# Lendlease – Retirement Living proposed DA at 207 Forest Way, Belrose

## Review of waterway definition

# Lendlease – Retirement Living proposed DA at 207 Forest Way, Belrose. Review of waterway definition

Figure 3. Slope of the upper part of the catchment of Snake Creek.

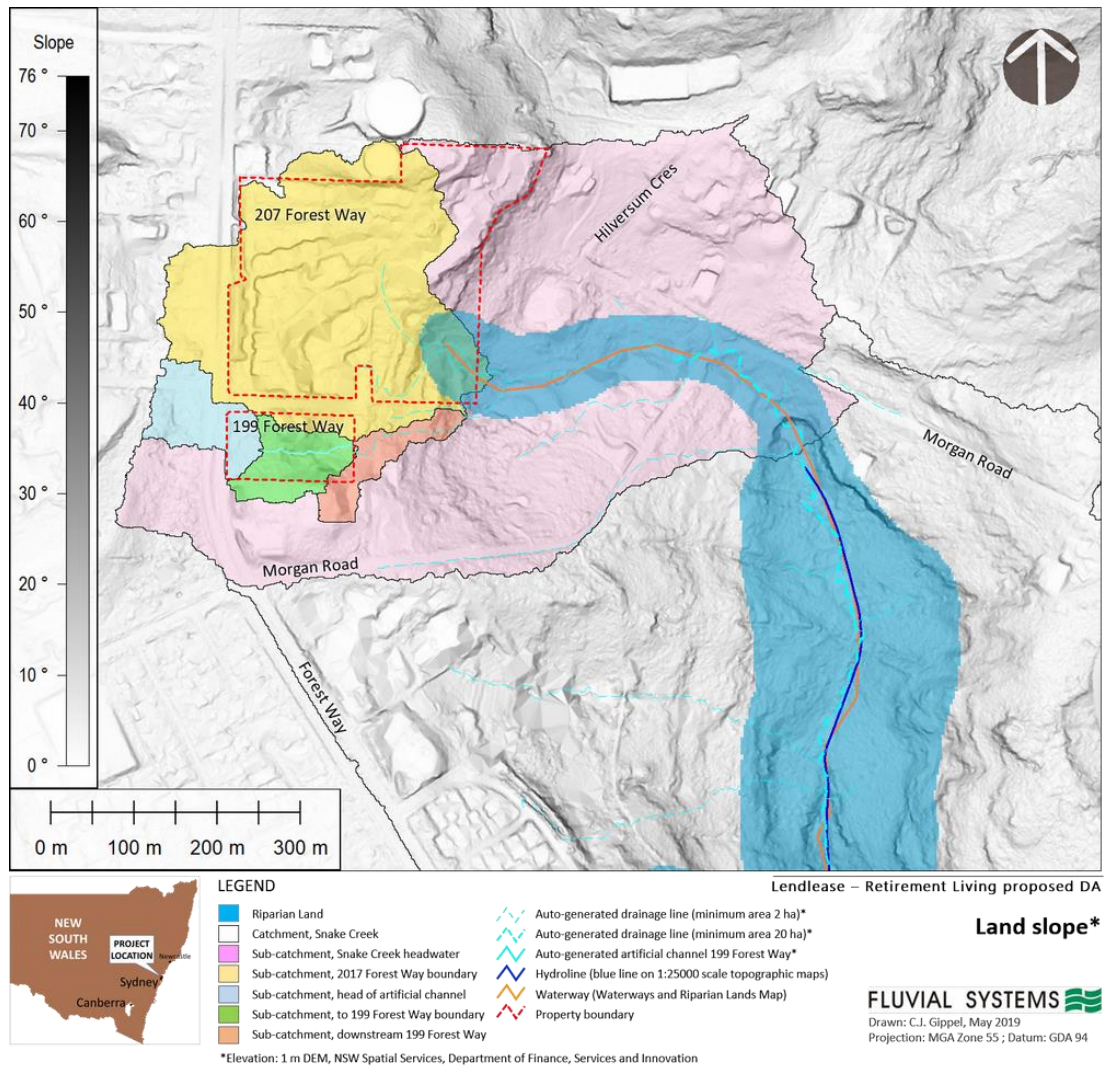
Drainage lines and sub-catchments for Oxford Creek catchment, including Snake Creek sub-catchment, were automatically generated using the ‘Generate Watershed’ algorithm in Global Mapper GIS (Geographic Information System), with the minimum sub-catchment area set to 20 ha. This produced drainage lines that were less extensive than the 1:25,000 blue lines (hydrolines) (Figure 1), indicating that some of the catchments draining to the top of blue lines are less than 20 ha in area. This was not the case for upper Snake Creek, where the blue line was shorter than the auto-generated drainage line (Figure 2). The catchment draining to the top of the blue line was 35.60 ha. In preparing the topographic map, the cartographers decided to begin Snake Creek blue line at the base of a 10 m high, near vertical (slope up to 70 degrees) rock knickpoint (Figure 3).

Figure 4. Detail of drainage of land around 207 Forest Way, Belrose.

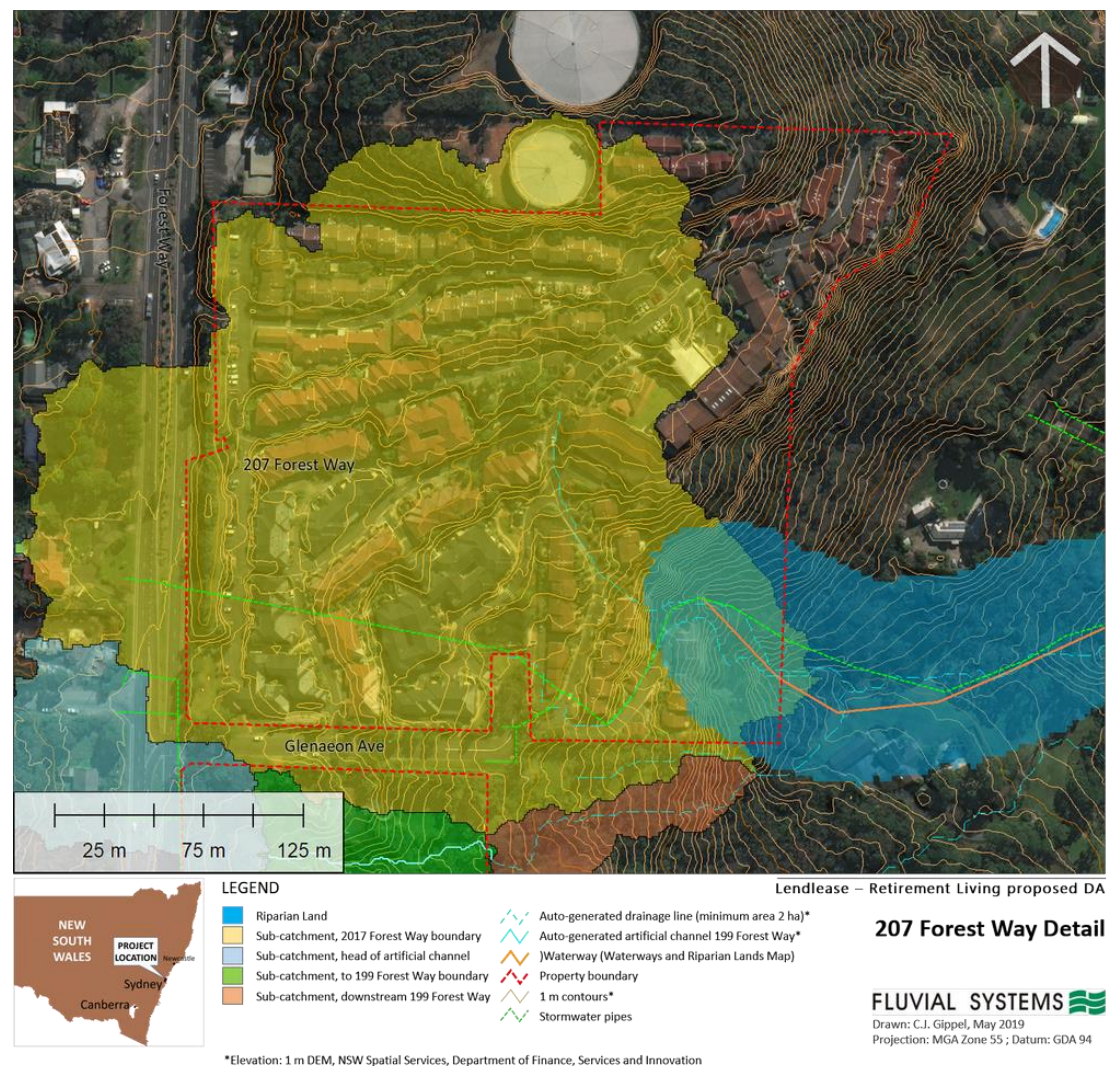
The Riparian Assessment by Cardno (2018) argued that the Map of Waterways and Riparian Lands (MWH, 2004) erred in extending the Snake Creek headwater tributary drainage line into the land covered by 207 Forest Way, Belrose (Figure 4).

Cardno (2018) accurately described the area in question as heavily modified by urbanisation and stormwater management. This includes Council-owned stormwater drainage (Figure 4) that empties to a series of three existing sedimentation basins that lie within the area of the proposed development. Downstream of the sediment basins, on the adjoining property, a dam was constructed some time between October 2012 and April 2013. The Council Waterways line projects through these structures to approximately the base of a sandstone escarpment (Figure 3, Figure 4). For a distance of about 70 m downstream of the dam, the land over which the Council Waterways line is drawn is grassed, and no channel is evident.

I agree with the conclusion of Cardno (2018) that the upper reaches of the Waterways line drawn by Council that projects into 207 Forest Way is artificial and does not possess characteristics that define a watercourse according to the legislation, policy and case law reviewed in this report. The watercourse satisfies the Warringah Creek Management Study (2004) liberal morphology and hydrology requirements, but lacks a continuous linear vegetation assemblage that could also define a watercourse.

Figure 5. Parish Map of area covering location of proposed development.

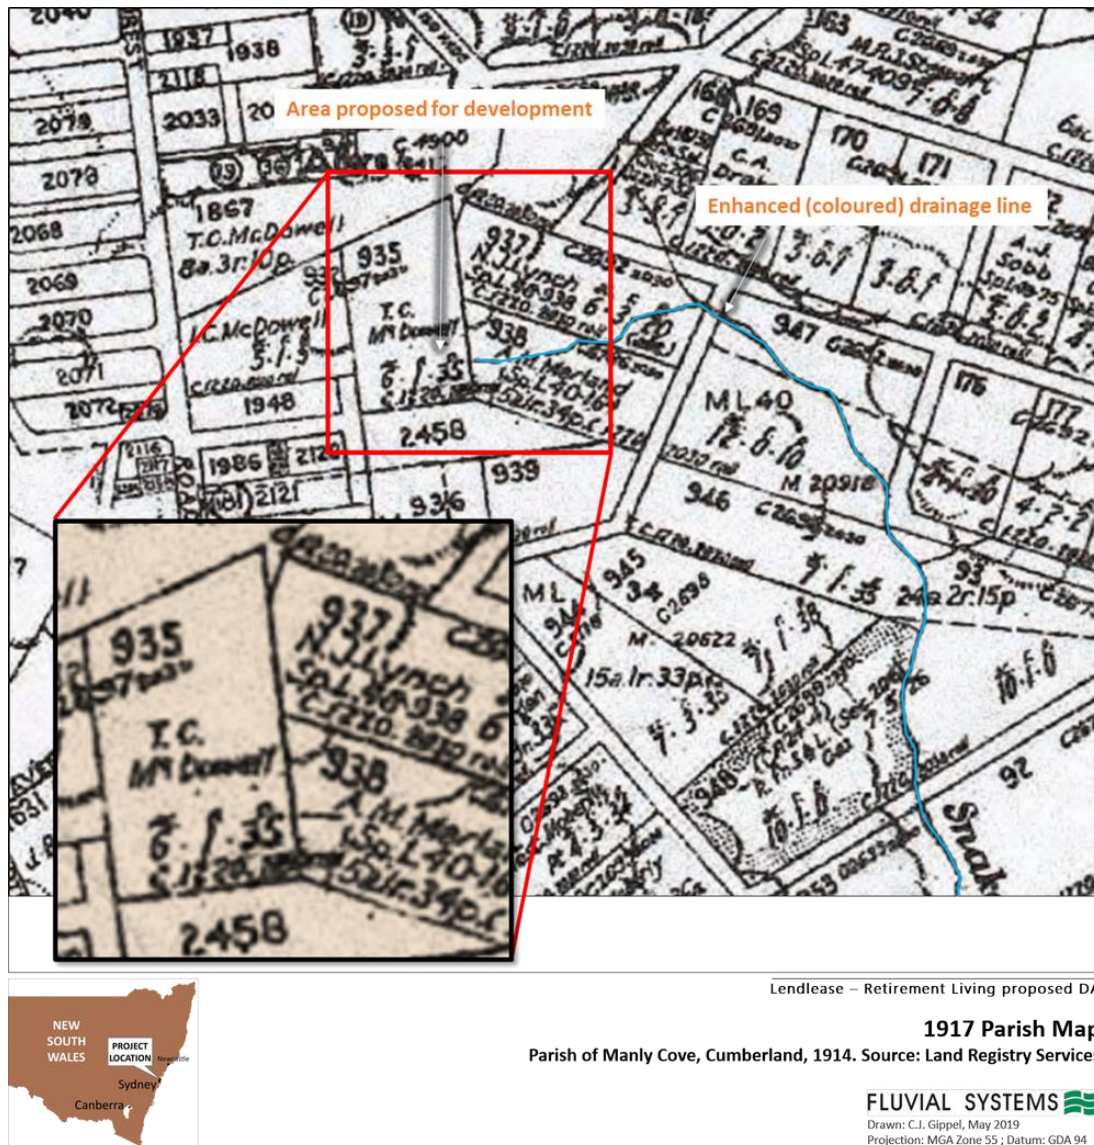
From the perspective of WLEP 2000, EP&A Act 1979 and WM Act 2000 definitions, the issue mainly hinges on whether the section of drainage line in question is an artificial waterbody, or an artificially modified natural waterbody. Topographically, the area naturally was, and is, a runoff flow path, but nearly all land in catchments drains water downhill under storm event conditions, so a runoff path alone does not make a watercourse. According to most legal definitions of watercourse, the flow must be confined, and a channel and other characteristic properties would be present. When the 1:25,000 maps were drawn, the cartographers decided the drainage path did not possess sufficient characteristics of a watercourse to be marked as a blue line. For this reason the flow path would not normally meet the WM Act 2000 definition of a watercourse. An earlier 1917 Parish Map did draw the drainage line extending further upstream than the 1:25,000 blue line, but it stops just short of the boundary of 207 Forest Way (Figure 5).
